BODY HOLDDOWNS AT REAR AXLE

PARTS UPDATE #16-04

CHANGE FROM SINGLE TO DOUBLE HOLE MOUNTING TO BODY

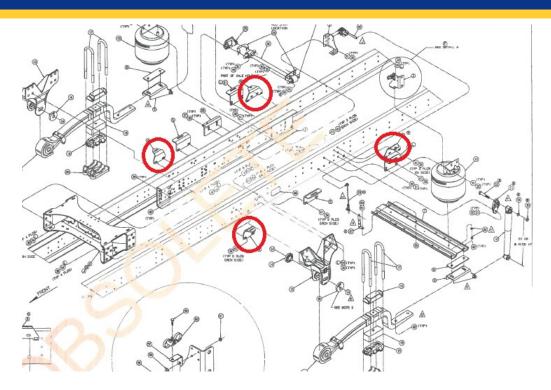
Blue Bird is making a change to the body hold-downs located just ahead of and behind the rear axle, as shown in the diagram above. Previously these brackets mounted to the body crossmember with a single bolt. Two (2) bolts will now hold the updated brackets to the body cross members.

Bolts used for mounting the new brackets are 7/16-20 x 1-1/2 grade 5 with a Stover locknut and double washer.

Standard Floor

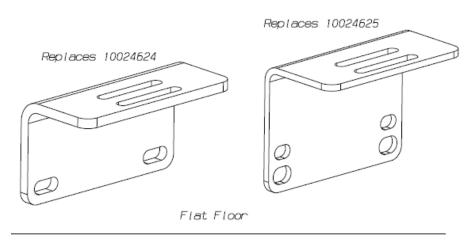
Replaces 10024623

Single Bolt	Double Bolt
10024623	10044125
10024374	10044126

Single Bolt	Double Bolt
10024624	10044136
10024625	10044135
ATTACHING HARDWARE	
BOLT	#00525342
